PILGRIM NUCLEAR POWER STATION

Amendment No. 78
License No. DPR-35

ATTACHMENT TO LICENSE AMENDMENT NO. 78

SAFETY EVALUATION BY THE OFFICE OF NUCLEAR REACTOR REGULATION
SUPPORTING AMENDMENT NO. 78 TO FACILITY OPERATING LICENSE NO. DPR-35
BOSTON EDISON COMPANY
PILGRIM NUCLEAR POWER STATION
DOCKET NO. 50-293

FIGURE 3.11-4
MAXIMUM AVERAGE PLANAR LINEAR HEAT GENERATION RATE
VERSUS
PLANAR AVERAGE EXPOSURE

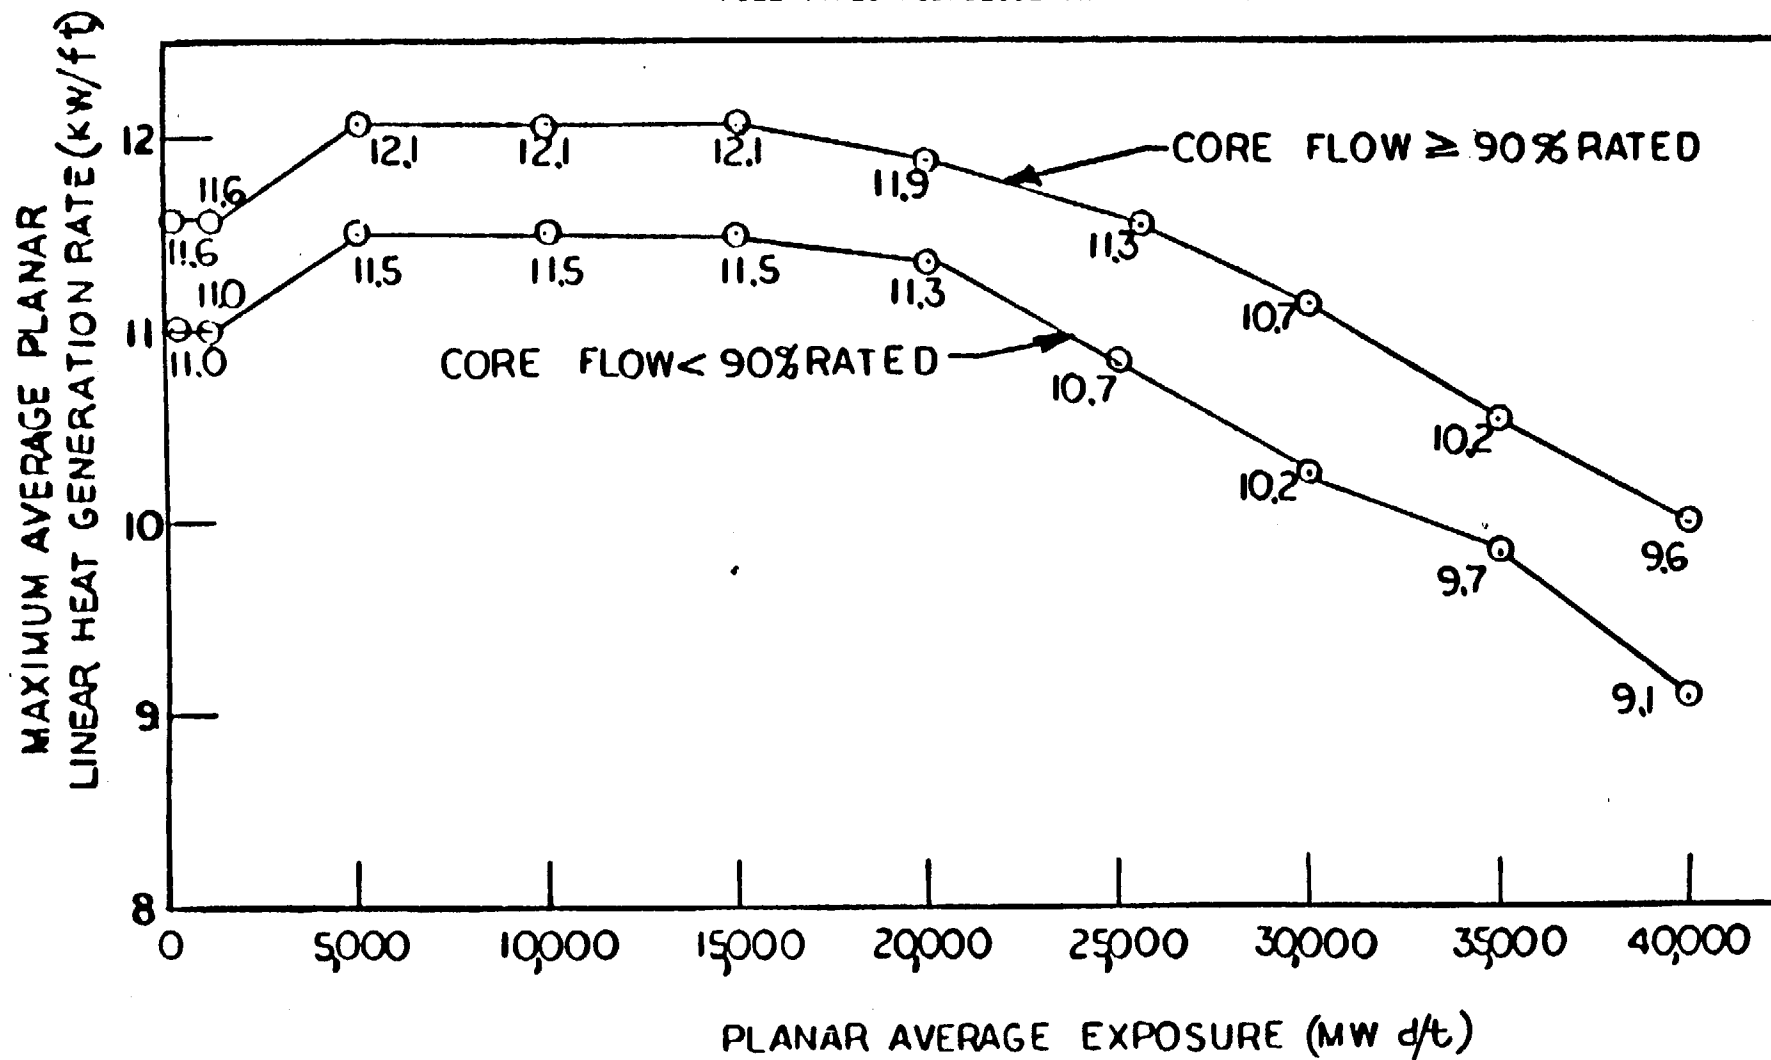
The maximum average planar linear heat generation rate (MAPLHGR) versus planar average exposure curves in Technical Specification Figures 3.11-4,

5, and 6 are being modified to include reference to the barrier-type fuel that will be used in Pilgrim Cycle 7. The staff has found the use of the barrier-type fuel acceptable (Ref. 5); therefore, these are acceptable Technical Specification changes (pages 205E-4, 205E-5, and 205E-6).

FUEL TYPES P8DRB265L and BPDRB265L
